GLIDING FEDERATION OF AUSTRALIA

AIRWORTHINESS DIRECTIVE GLIDERS:

Ref. No. GFA/AD 187 Glasflugel 11

Glasflugel H201 and H201B to serial No. 476  
and H301 and H301B, all serial numbers.

(X) Position of possible cracks on original Elevator Linkage

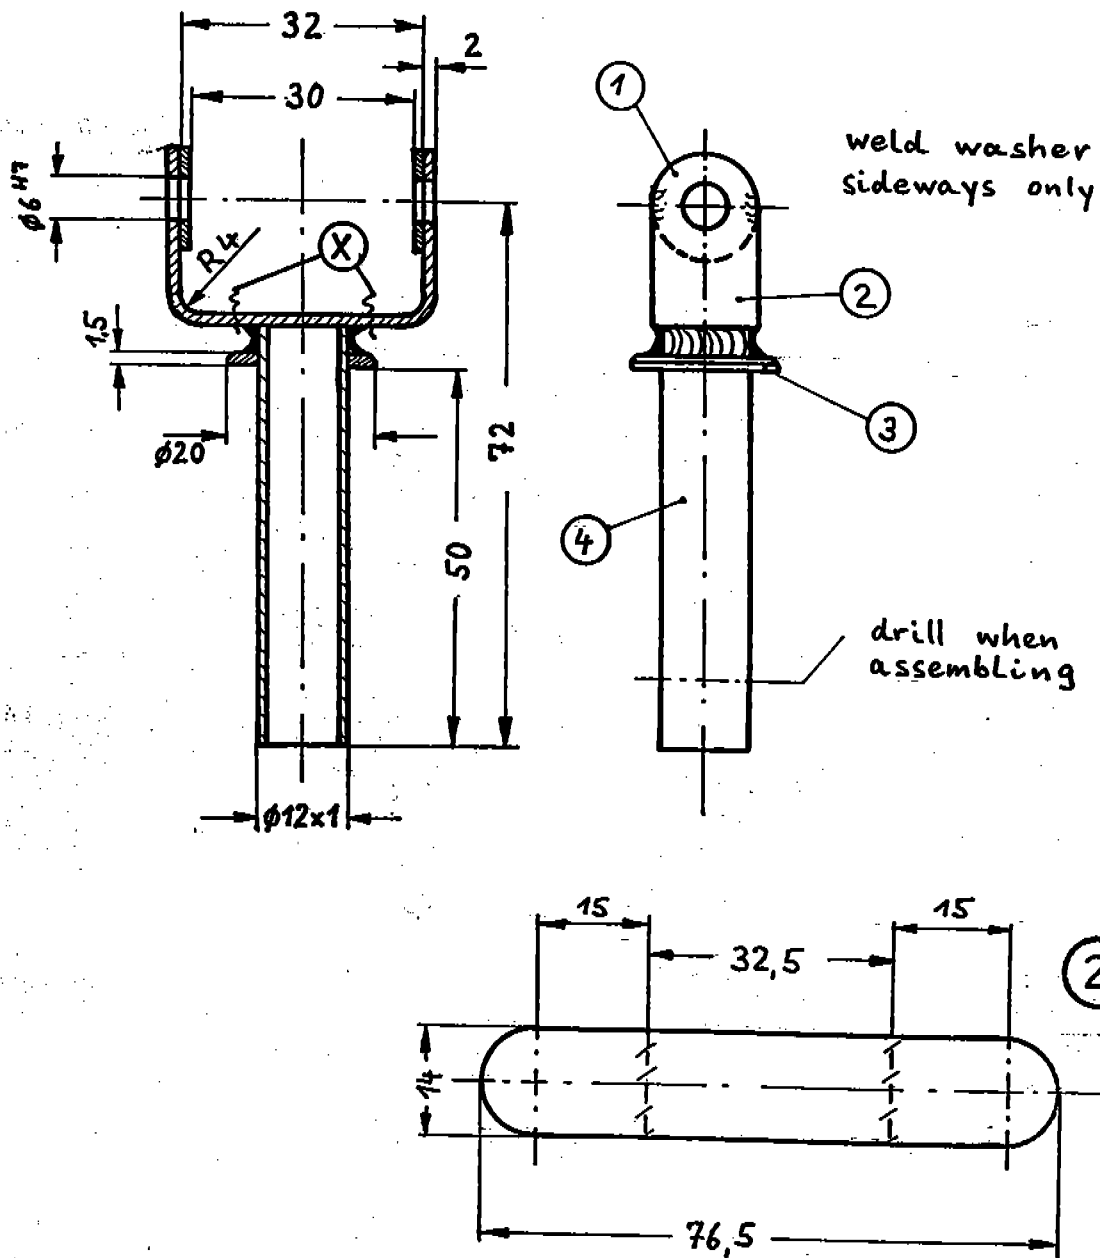
Failure of a component in the elevator control circuit at the base of the control column has occurred. The nature of the failure was such that it may be expected to occur in other gliders of the subject type.

1. Before further flight, the elevator linkage component (see illustration of modified component) is to be inspected. Inspection is to be carried out by a holder of a Glider Inspector's Certificate D.O.T 1109 endorsed for Certificate of Airworthiness Inspectors experienced in crack detection in metals. Inspection is to be carried out using a magnifying glass with at least 5 x magnification.

This inspection must also be carried out following the application of high loads to the glider (e.g. hard landings or ground loops). If any cracks are found, the glider must not be flown until the defective component has been replaced.

2. The modified elevator linkage component according to drawing No. 301-41-4/2 is available from Glasflugel, 7318 Lenningen 1, West Germany or Australian Agent,

and must be ordered before 30th October, 1980 in order to be available for replacement before 30th December, 1980 by which time existing component must be replaced.

Installation of the new component is to be inspected and certified in the glider's log book by a Glider Inspector as for Action 1 and in addition is to be independently inspected by Glider Inspector holding a Glider Inspectors Certificate D.O.T. endorsed for Daily Inspections or higher category.

heat-treatment after welding: Tempering in controlled atmosphere  
1 hour at 550°C
